80286 (B-2/B-3) Information Sheet
21 November 1984

Errata Items:

Documentation Corrections:

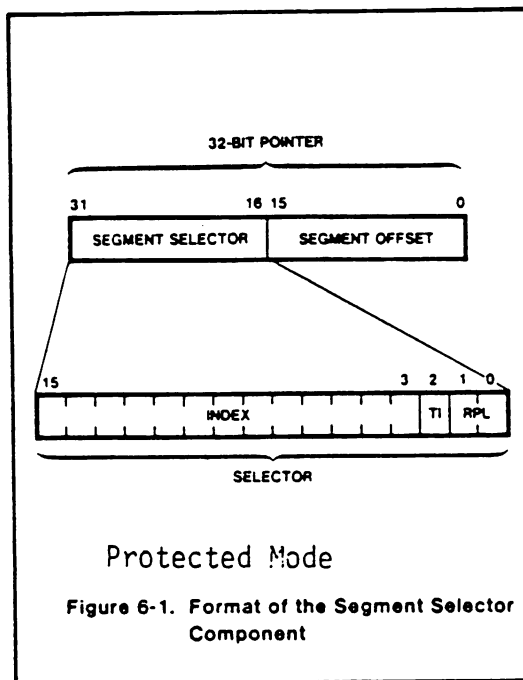
9. **LOADING NULL SELECTOR VALUES INTO DS OR ES REGISTERS**
 This isn't usually a problem, since any of the 4 null selector values are equivalent in purpose. Just be aware of it: in Protected Mode, when any of the 4 null selector values (the 4 possible null selectors are 0000H, 0001H, 0002H and 0003H) are loaded into DS or ES registers via a MOV or POP instruction or a task switch, note the 80286 always loads the null selector 0000H into the corresponding registers. The 80286 will be improved to load all 4 null selector values literally. In Real Mode all values loaded into DS or ES are of course loaded unaltered.

Background: In Protected Mode, the null selector is any selector (see Figure below) whose Index bits and Table Indicator bit are all zero. Since the 2-bit RPL field may be 00, 01, 10 or 11 there are 4 possible null selectors. In hex format, the 4 possible null selectors are 0000H, 0001H, 0002H and 0003H. They all serve as "null" values, and a general protection violation correctly occurs if software attempts to access the data segment or extra segment when a null selector is in the corresponding segment register.
